FILE ## _ G 14512

WATER RESOURCES DEPARTMENT MEMORANDUM

FROM:	Ground Water/Hydrolog Doug Woodcock	•		19-97
SUBJECT:	Groundwater Application	on G- 17572	-	
	eekzs_ gpm (ROGHE	basin
Applicants Na Proposed Use:	me: Roome Comy. C. Dom/ IRR.	olleg6	SAND CR	
Legal Down Well is Well Element Well down Cased town Well test (Confine well to the well test (Confine well test well to the well to the well test well to the well to the well test well to the w	WRD# Jose 4436 T 365 Fescription 2'5 + 82 2600 ft from ft from evation - 1030 ft evation - River/Stream expth 166 to 27 to 54 and types ed/Semi-confined/Uncoll to cause substantial into	River/Stream elevation	(rivelevation 770 / 770	er/stream) er/stream) ft. ft. 7/24/74 ft ft ft ft ft
Legal D Well is Well is Well El Well de Sealed Cased Lined to (Confin	WRD#TF escriptionft fromft from evationft from evation - River/Stream expth to t and types ed/Semi-confined/Uncoll to cause substantial interpretation	River/Stream elevation ft SWL _ ft Depth f ft Perferat ft Perferat	(riv (riv elevation ft on irst water found tions/screens tions/screens ydraulic connection?	er/stream) er/stream) ft. ft. ft. ft. ft

RCC #1 (Middle Well) T36S/R6W-27acd1 Jose 4322

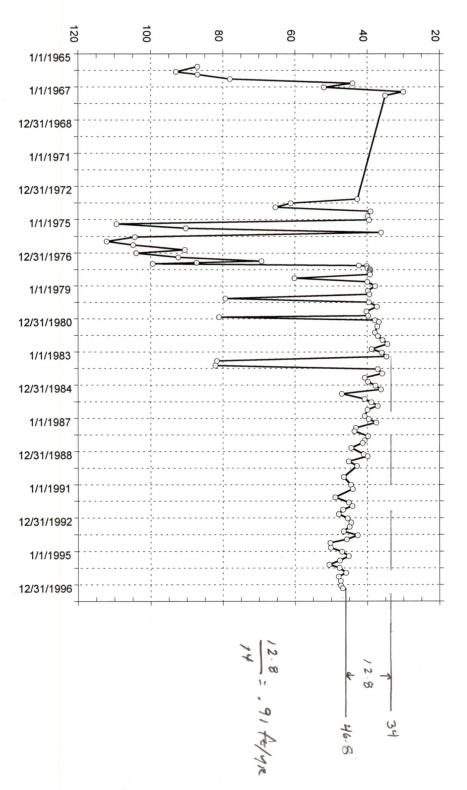
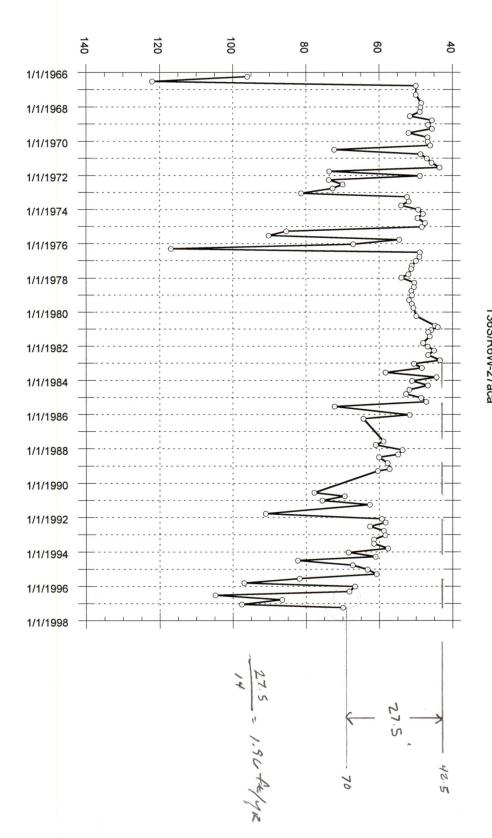
THIS IS OBS IN 1983. THE SU DECLINE DOES INTERFERENCE COORDINATE IN HAVING A PR EXISTING US	WELL IS DEVELOPED IS GRIDELLE IS DECLINE IS NOT APPEAR TO BE COLLECTION WITH OWNER OF COLLECTION GOODS COLLECTIONAL STRESS USED: GRANTS PASS	DECREASING TO EXCESSIVE, LO TA - LOOKING FO GOOD QUARTE STATIC MEMTS ON THE SYSTEM	THE LAST FEW YEAR W POTENTIAL FOR POR A PLAN ON HO ERLY MEASUREME IN SOME CASES,) IS NOT ANTICIPATE	INE SINCE ESUBSTANTIAL OW RCC WILL NTS. (WE'RE AT THIS IS AN
